Apex Fashion Wear Limited

23rd October 2018 & 24th November 2018

Observations

Gap & Poor detail between steel baseplate and RC column

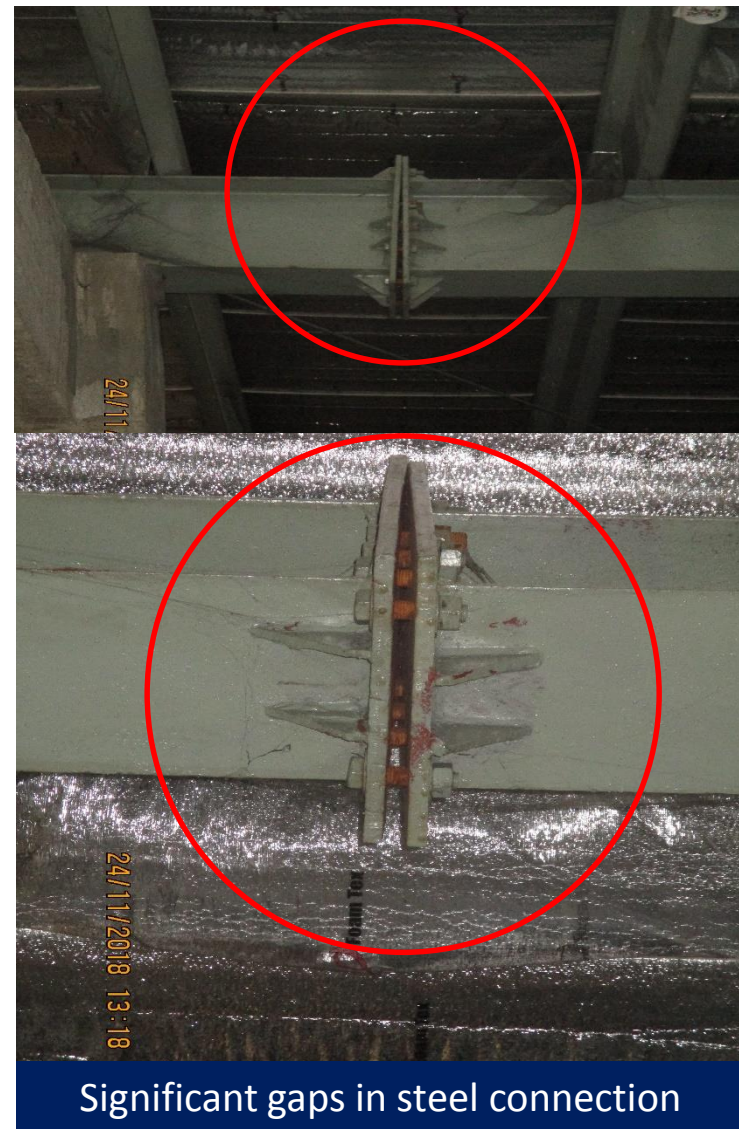
Apparently inadequate bearing area in joint

Flange discontinued joint connection

Two bolts connected in other side of the flange

Poor connection detail between steel baseplate and RCC column. Also gap between baseplate & column observed. Building engineer is required to check the connection adequacy for uplift pressure.

Existence of gaps & bolt missing in steel connection

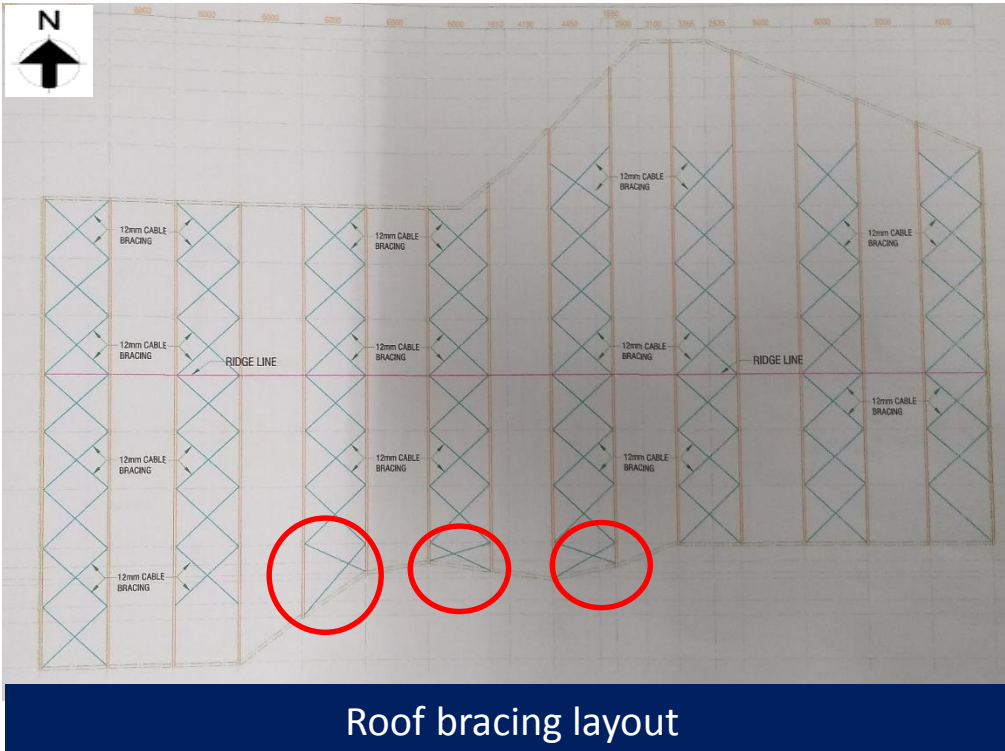
Missing bolts in steel connection

Significant gaps in steel connection

Significant gaps & missing bolts were observed in rafter connections. Building engineer is required to carry out suitable remedial works.
